ACCESSORIES MARKING

SERVICE INFORMATION LETTER 2023_04

Products affected:	All perforated lids (aluminium and stainless steel)
Change level:	 □ optional □ recommend by MBV □ mandatory ☑ for information only

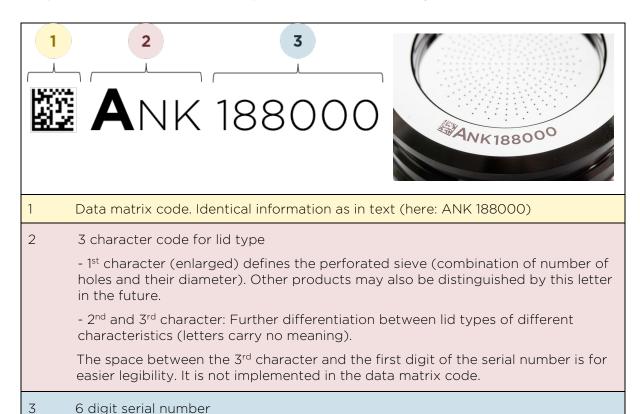
To permit tracing and to prevent using unsuitable perforated lids MBV decided to mark every lid with a unique and non-removable identification.

The marking includes information on the lid-type and a unique serial number. The complete information is presented in a human-readable form by letters and numbers and in a camera scannable 2D barcode.

Lids that were marked before this change (e.g. all stainless steel perforated lids, specialty aluminium perforated lids) will integrated in the new labeling system described below. The old marking will disappear.

We employ a picosecond laser-based marking technology ('black marking') that leads to very dark, high-contrast markings without significantly altering the properties of the metal surface. The technology is well established and accepted for marking medical device implants and other applications that require highly corrosion-resistant surfaces.

- Deep-black coloration with high contrast and matte appearance with low reflections which improves readability by 2D barcode scanners.
- Corrosion resistance. Markings remain legible even after numerous cleaning and decontamination cycles.
- Wide viewing angle consistency.
